**FINAL DRAINAGE REPORT
FOR**

MOUNTAIN VIEW ACADEMY

TRACT H, CLAREMONT RANCH, FILING NO. 4

Add "PCD File No. EGP-20-002"

Drainage Map

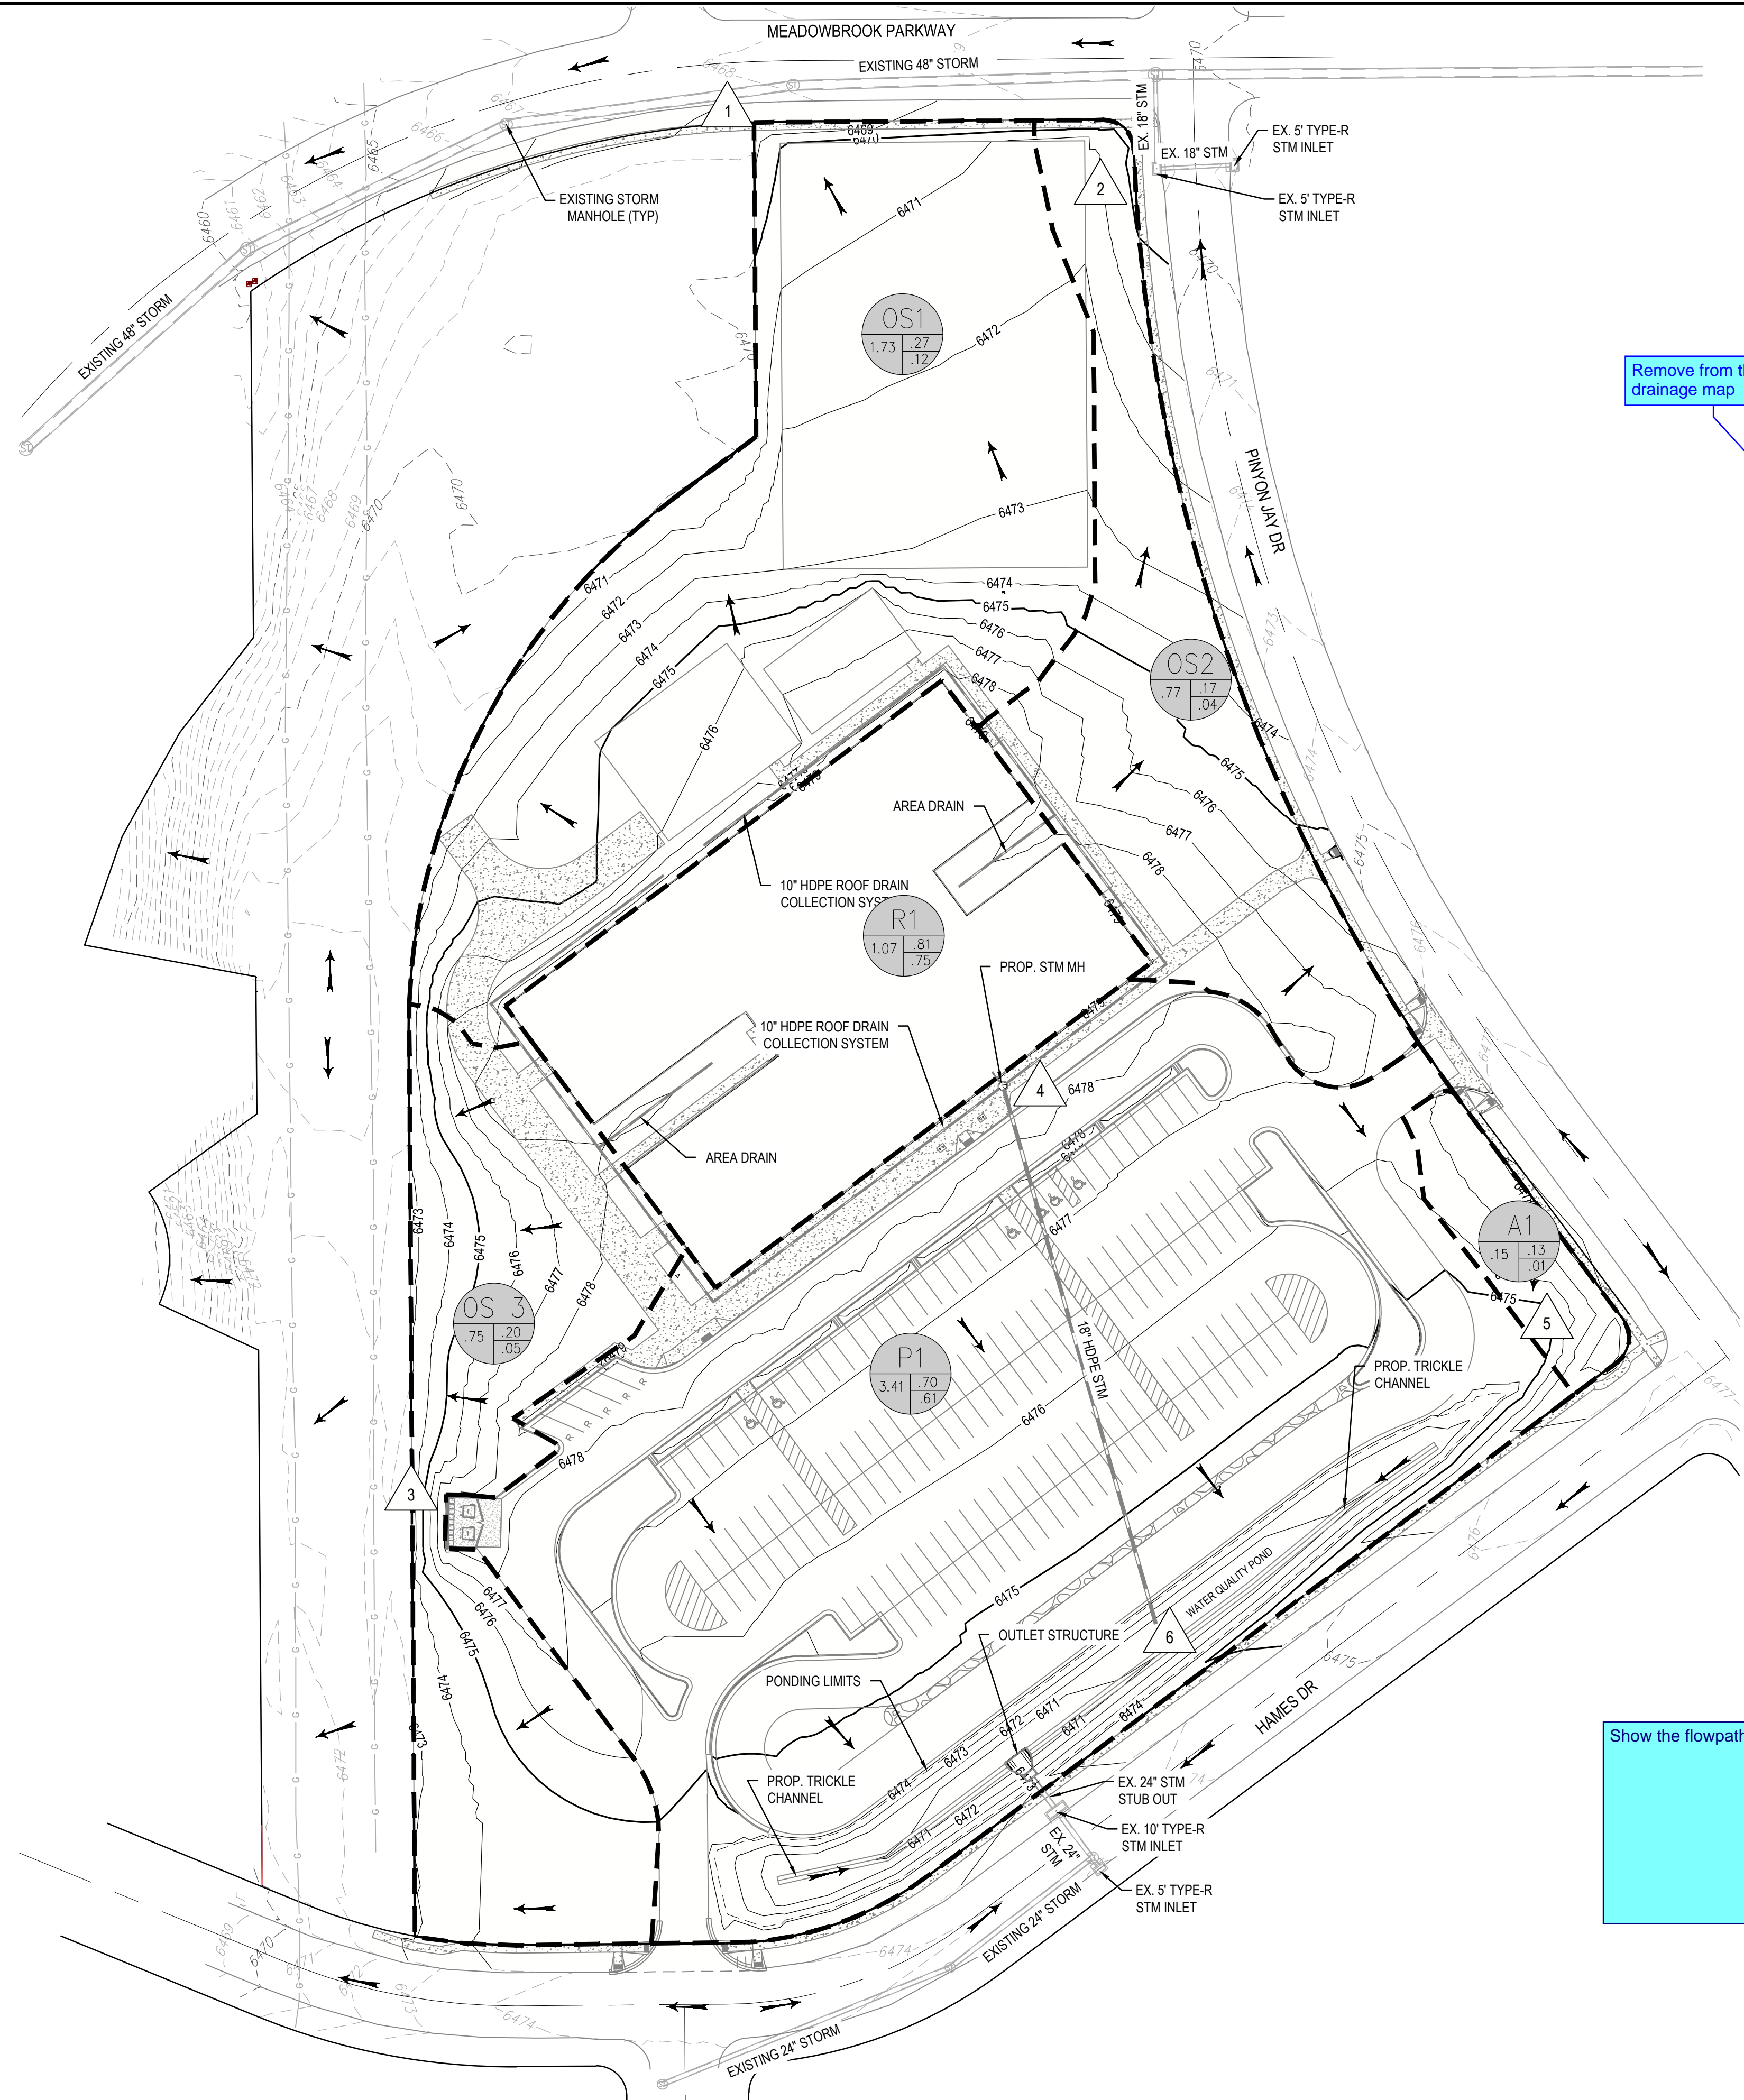
Revise. Per ECM Appendix I Section I.7.1.A the entire site to include basins OS1, OS2, OS3, and A1 must be treated for WQ unless excluded from the requirements as described in I.7.1.B. On the subbasin narrative, specifically identify the exclusion criteria being applied.
